Construction Traffic Management Plan

The Bays – Stage 1 – Site Establishment Rev 01

Project number	7040
Document number	SMWSTETP-JCG-SWD-SN000-TF-PLN-002049

REVIEW COMMENTS SHEET

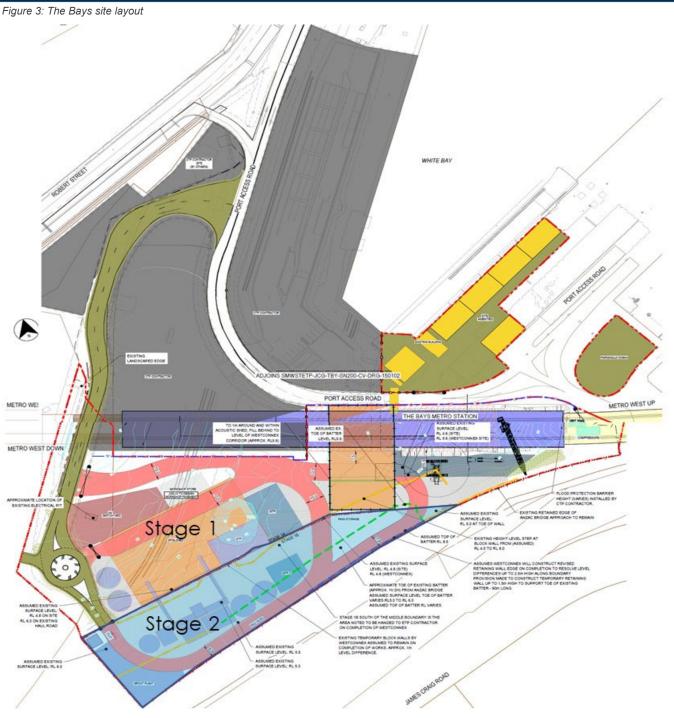
SMWSTETP-JCG- SWD-SN000-TF-PLN-Ta 002049	able 17	NA	Table 17 and 18 has been updated to address this comment.	Observation	Ν
				26	20/02/2023	RMS	HYOUSAF	SMWSTETP-JCG- SWD-SN000-PM-PLN-Se 002049	ection 1.3	NA	Remove the reference of overarching CTMP in paragraph- 2 from all site specific CTMPs. This is not the overarching CTMP.	Observation	Ν
								SMWSTETP-JCG- SWD-SN000-PM-PLN-Se 002049	ection 1.3	NA	The intent of the OCTMP reference in section 1.3 is to explain the purpose of the OCTMP and how it interfaces with the site specific CTMP.	Observation	Ν
				27	20/02/2023	RMS	HYOUSAF	SMWSTETP-JCG- SWD-SN000-PM-PLN Se 002049	ection 6.1	NA	Clarify the construction stage naming conventions. are there two stages in stage 1 (1A and 1B) ??. in many sections and figures, it is mentioned as stage 2 instead of 1B. Please add a table specifying all stages 1, 2, 3 and so on and against each stage mention any substages and also the specific name given to these stages based on the activities (site est., demolition, tunnelling etc. and so on). Do this for all CTMPs.	f Observation	Ν

SMWSTETP-JCG- SWD-SN000-PM-PLN·Se 002049	ection 6.1	NA	Section 6.1 and Figure 3 have been updated to address the comment	Observation	N
				28	20/02/2023	RMS	HYOUSAF	SMWSTETP-JCG- SWD-SN000-PM-PLN- 002049	ection 6.2, Bullet point	NA	Will CTP retain eastern half or western half? It contradicts with figure 6 and others.	Observation	N
								SMWSTETP-JCG- SWD-SN000-PM-PLN 1 002049	ection 6.2, Bullet point	NA	Section 6.2 references the Station Box which is denoted by the large purple rectange the centre of Figure 3, CTP will retain the eastern half of the station box.	Observation	N
				29	20/02/2023	RMS	HYOUSAF	SMWSTETP-JCG- SWD-SN000-PM-PLN Se 002049	ection 6.5	NA	Review access and egress movement fro all gates fro both tables. Many of them are incorrect. Review the tables and figure again. ETP1 cannot be right out, ETP2 cannot be left out, Is ETP4 access only gate? Conflicting info in tables and note under figure 5. ET5 conflicting info about ingress and egress in tables.	l Potential Non-Compliance	N

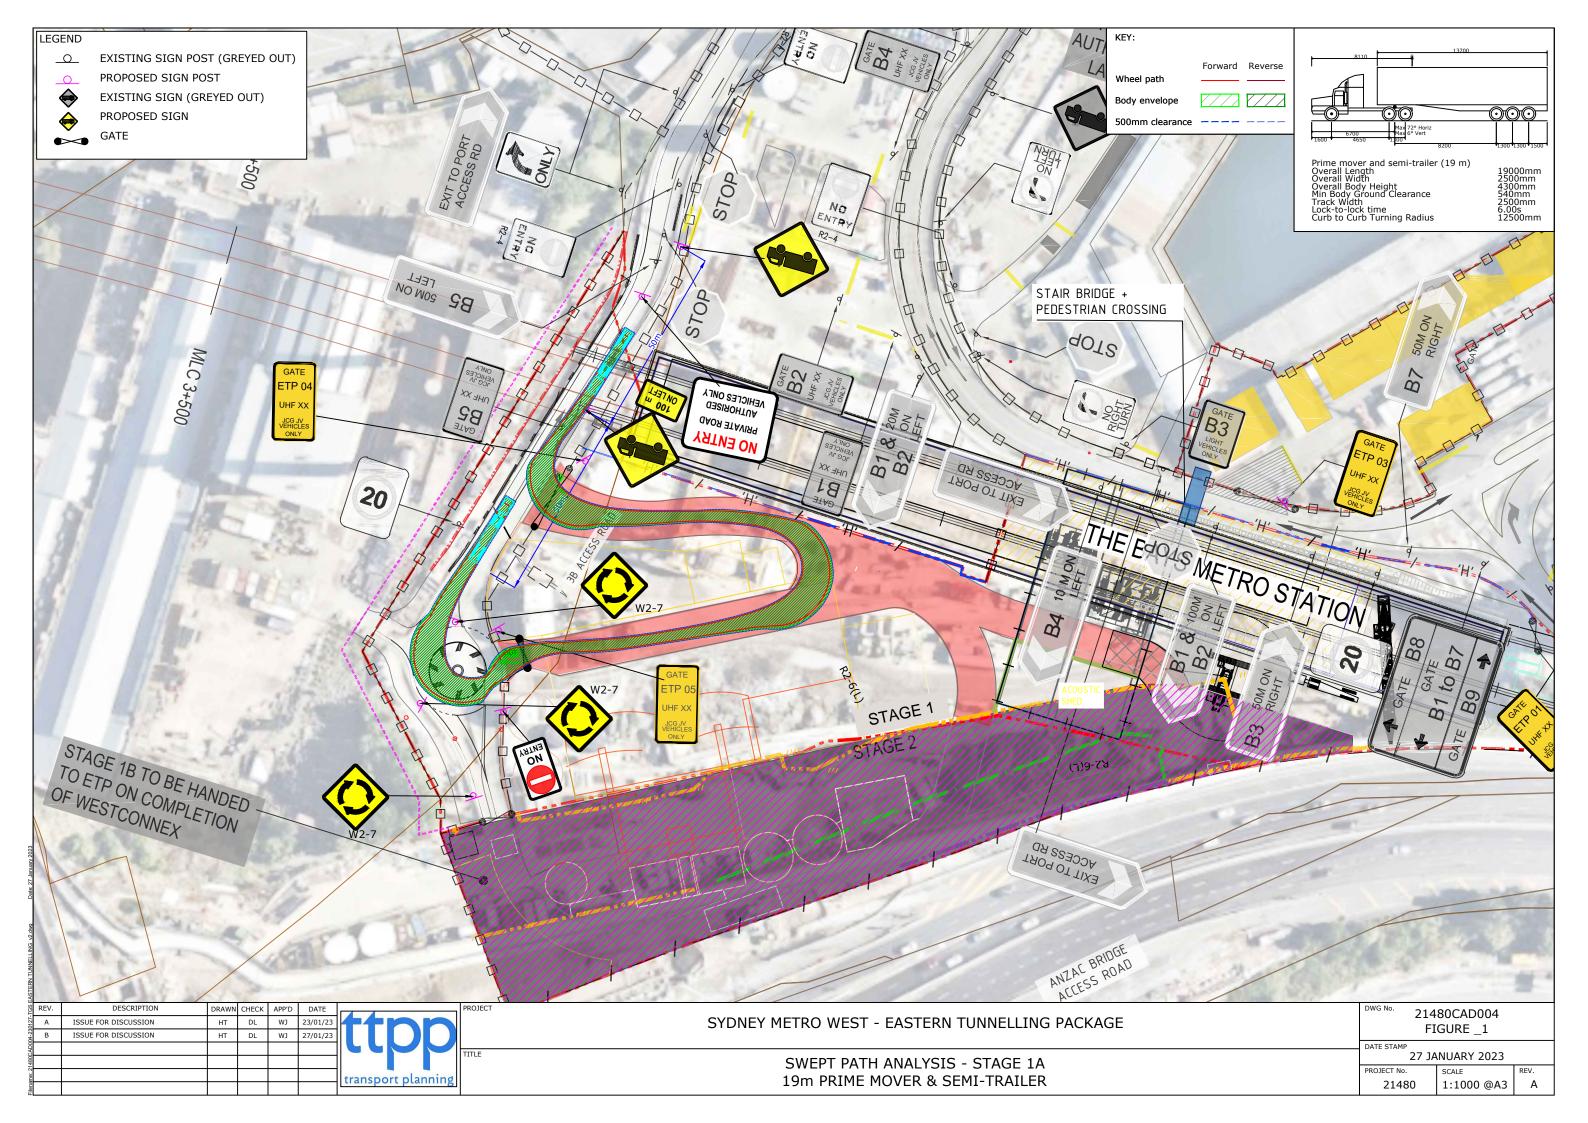
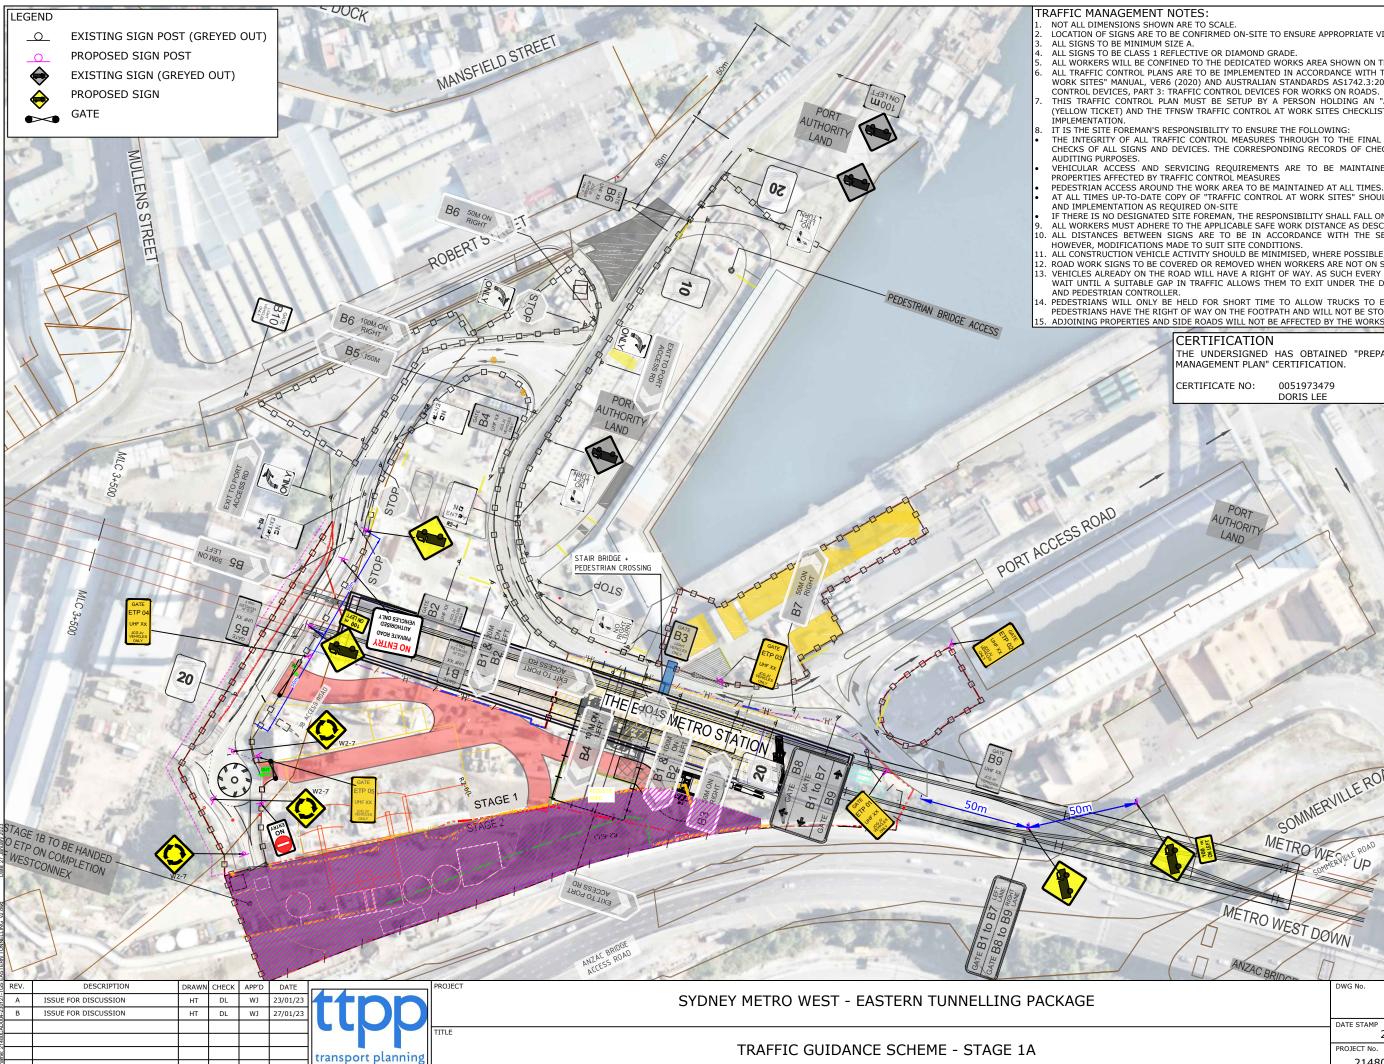
ltem No.	Location	Descriptions of Findings	Photo	Likelihood	Severity	Risk Rating	Designer Response
1.	Between temporary roundabout and Gate 4	The swept path analysis shows a potential overlap of northbound through and southbound left turning truck movements which could lead to potential head on or side swipe crashes between these two movements.		Possible	Minor	Medium	The gate has been relocated to the north to improve the swept path and eliminate the potential overlap of northbound and southbound vehicles.

2 Roundabout The plans show incorrect roundabout signs on each approach to the roundabout. The plan includes temporary (yellow diamond) roundabout warning signs. However, it should be the roundabout Give Way signs on the inverted triangle as these are the regulatory signs.
